Application for Works Approval Amendment

Works Approval Number	W6322/2019/1
Works Approval Holder	IB Operations Pty Ltd
ACN	165 513 557
File Number	DER2019/000575
Premises	Iron Bridge Magnetite Project Mining Tenements M45/1226, M45/1244, L45/293, L45/294, L45/359, L45/360, L45/361, L45/364 and L45/367 MARBLE BAR WA 6760 As defined by the Premises maps attached to the Revised Works Approval
Date of Report	04 January 2024
Decision	Revised works approval granted

TSF2 Embankment raise Stage 1B and 2

Figure 1: Indicative locations of scour pits

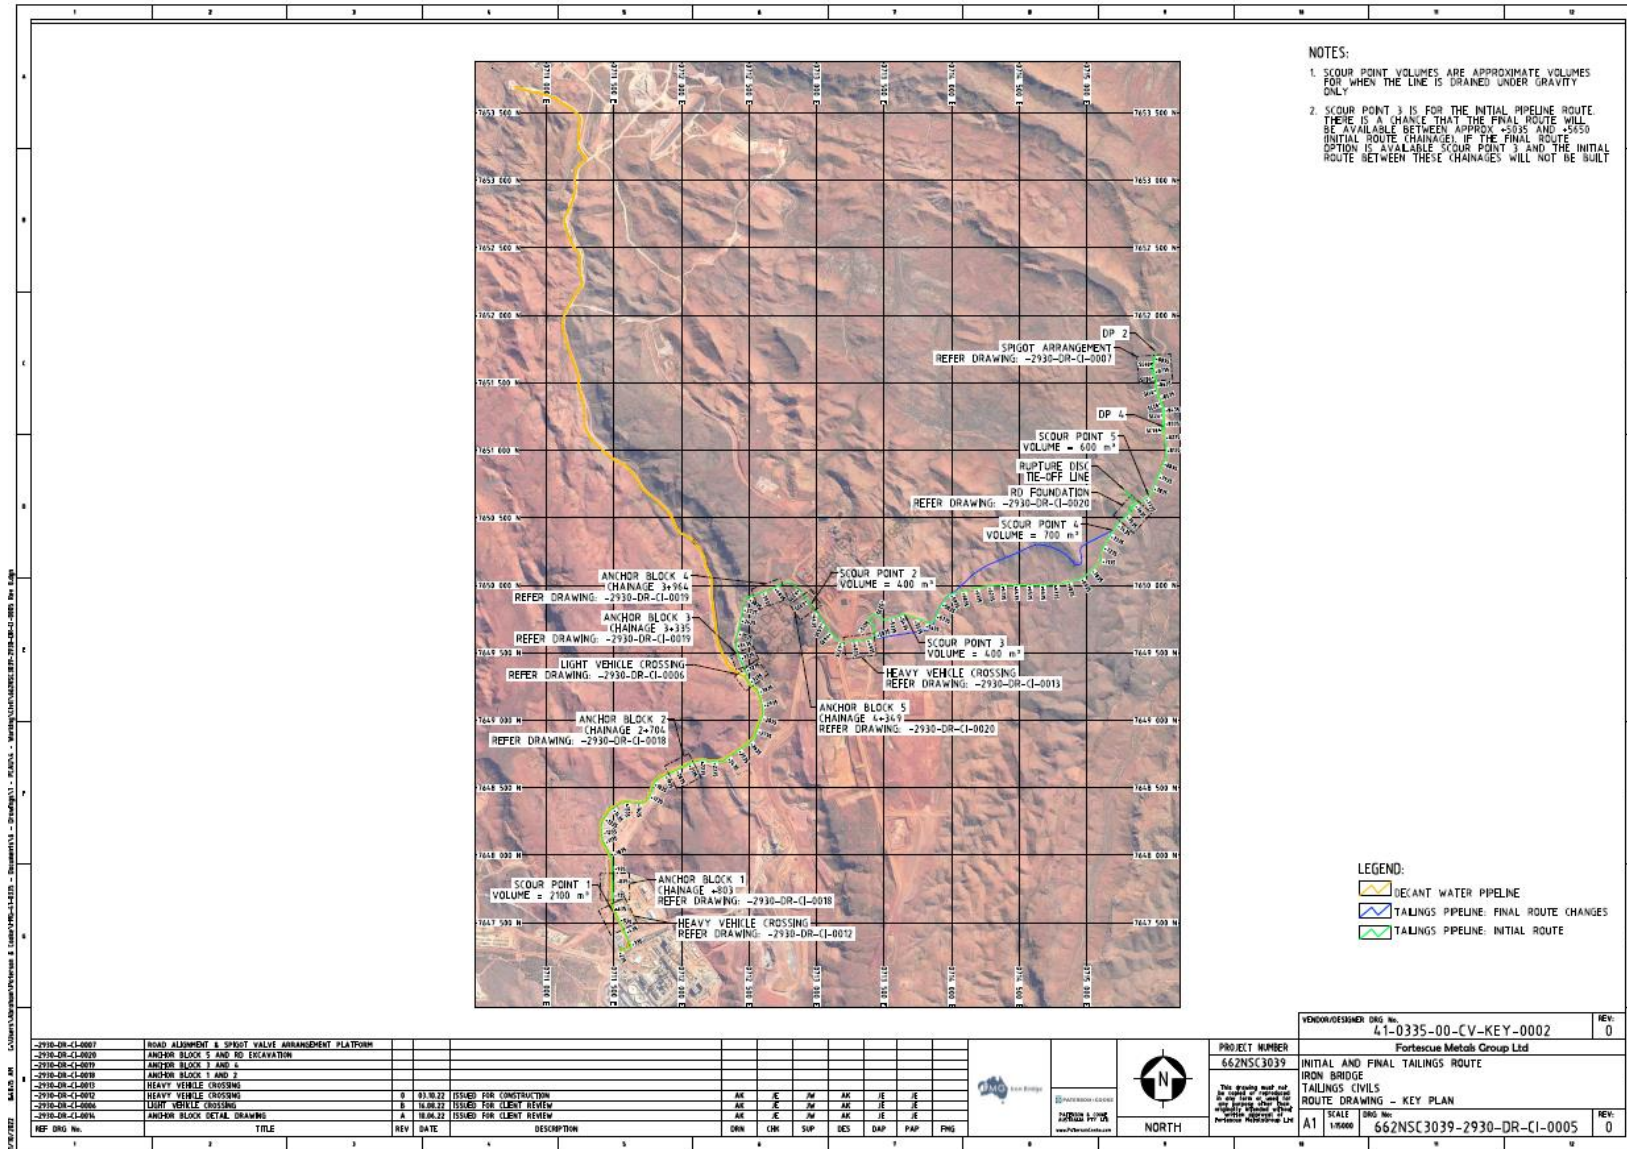
Scour pits have been proposed to be constructed along the tailings deposition pipeline at the indicative locations adjacent to the currently installed scour vales as shown in Figure 1. The purpose of the scour pits is to capture tailings in the event of a pipeline blockage or failure and to assist in ongoing maintenance of the pipeline. Design of each scour pit will take into consideration the topography and potential volume to retain. The pits will contain any tailings spillage until it has dried out for the material to be relocated back into the TSF. The works approval holder has stated that “*where the TSF is in close proximity to the tailings line and scour valve, with appropriate access and suitable topography, a scour pit will be redundant and instead a discharge line will run directly off the tailings line to deposit into the TSF.*” Proposed controls for the scour pits are listed under section 3.1.1, Table 2 and risk assessed under section 3.2, Table 4.

Use of scour pits	Tailings	Direct discharge and overland flow	<ul style="list-style-type: none"> maintain the integrity of the external bunds to reduce surface water interaction tailings once dried out must be removed from the scour pits following a scouring event, as soon as practicable any tailings spill that occurs on undisturbed ground in the process of scouring must be cleaned-up
